RE: Amerada Hess Corp – Port Reading Refinery
750 Cliff Rd
Woodbridge, Middlesex
EPA ID No. NJD045445483
PI #: 006148

AOC – 12 Smith Creek and Detention Basin Comments

The New Jersey Department of Environmental Protection (Department) has completed a review of the Smith Creek and Detention Basin AOC-12 Remedial Investigation Workplan dated August 2016 and amended by comments to USEPA on April 28, 2017, submitted pursuant to The Resource Conservation and Recovery Act (RCRA), and the NJDEP Technical Requirements for Site Remediation at N.J.A.C. 7:26E (Tech Rules). The RI Workplan must address these concerns in order to be acceptable under the Department's Technical Requirements for Site Remediation, N.J.A.C. 7:26E-4.1, Remedial Investigation Requirements. Presently, the RI Workplan is not consistent with the applicable Technical Requirements for Site Remediation (N.J.A.C. 7:26E-3 and 4), and NJDEP Guidance Documents including, but not limited to, the following:

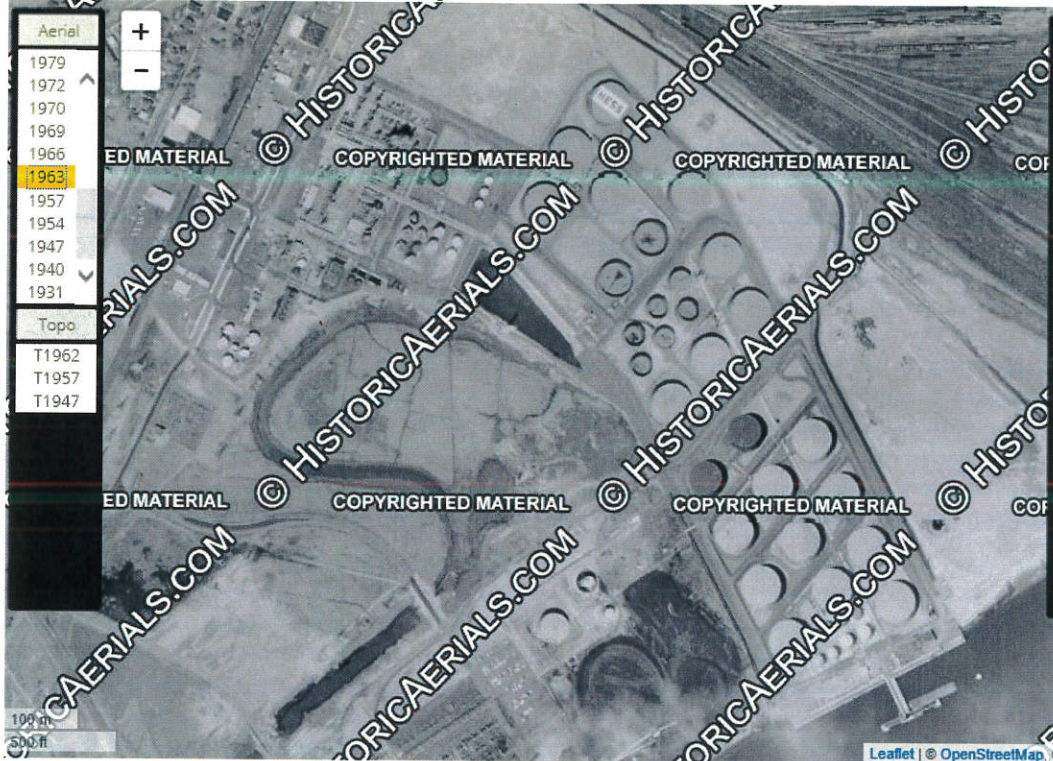
1957 and 1963 photos: the transition between on-site Smith Creek and off-site Smith Creek was modified, but the connection does not appear to have been eliminated. Fill was also placed under the bridges modifying flow connections. A release already appears to have occurred, prompting the changes at the bridges to flow, and apparent evidence of LNAPL impacts in the part of Smith Creek between the bridges.

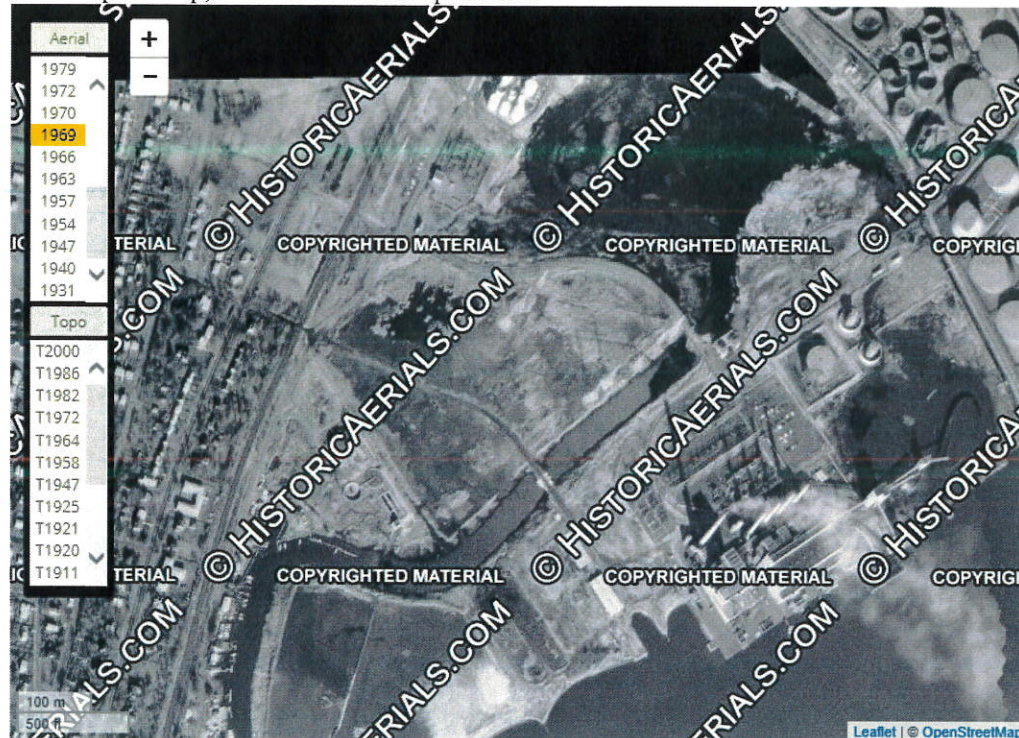
1963 and 1966 photos: apparent LNAPL impacts in Smith Creek between the two bridges. This predates the 1969 AST failure. Apparent ditch connection to on-site and off-site Smith Creek.

1969 photos: apparent LNAPL impacts from the 1969 AST failure to on-site filled areas, to on-site and off-site wetlands, and to surface water extending to a containment structure near the marina.

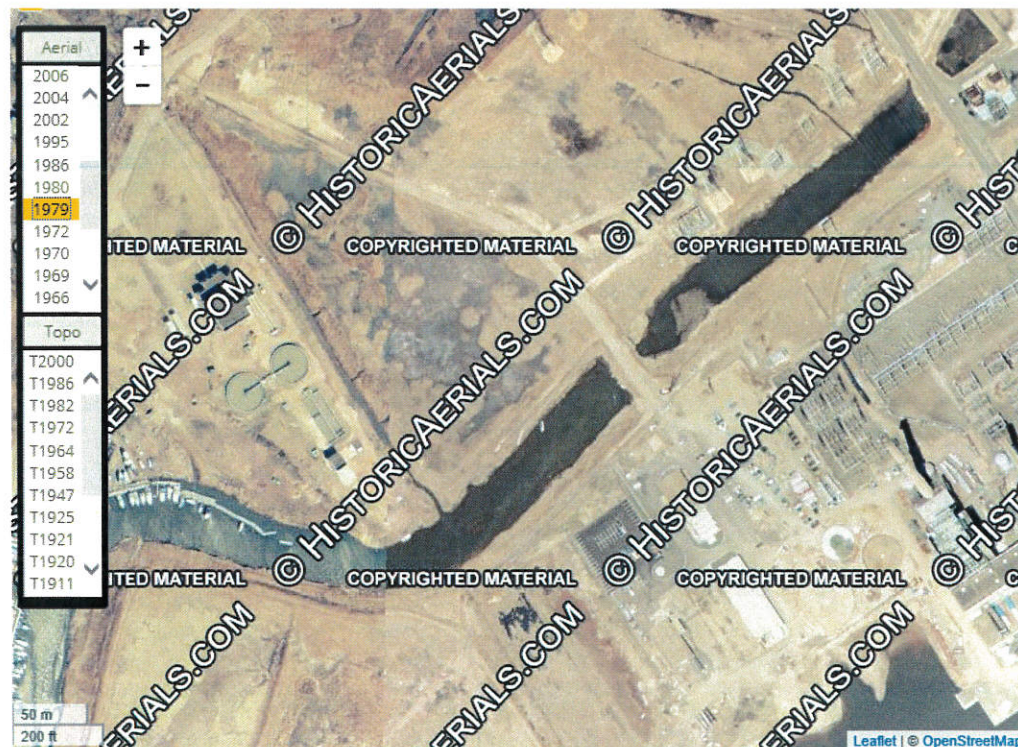
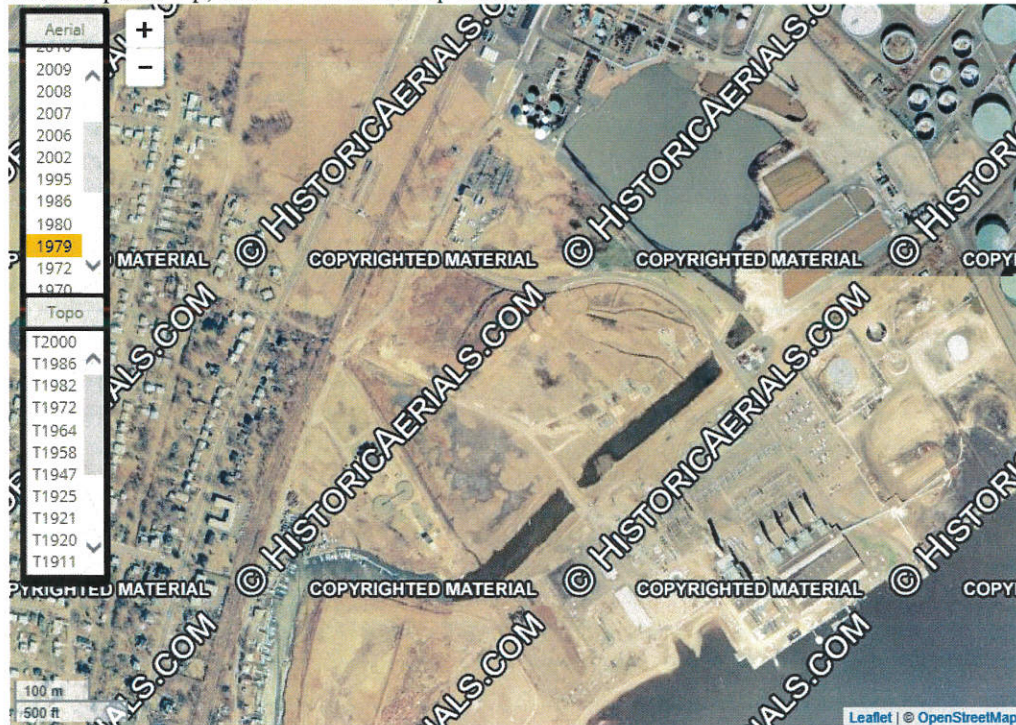
1970 photo: Continued presence of LNAPL. Changes in flow/fill in the isolated/semi-isolated portions of Smith Creek. Flow channels in lower flow areas.

1972 photo: completed dike construction shown that created the on-site detention basin (Smith Creek Pond) and a new “Head of Smith Creek” basin. Fill placed in the Smith Creek stream bed and wetlands between the dike and PSE&G generating station access road. Containment feature limiting Smith Creek flow near the marina was removed. Smith Creek flow conditions restored.

1972-1986 photos: continued fill placement in former on-site creek bed and wetland areas to construct (and then close) the mini-lagoon and the backwash lagoon, create land to construct wastewater treatment facilities, close the Oily Water Lagoon. Over time, fill continues to be placed over oily shorelines next to lagoons, the dike, the truck loading rack and day tank field areas, the API Separator, etc. Made land areas increase and detention basin/Smith Creek Pond area decreases.
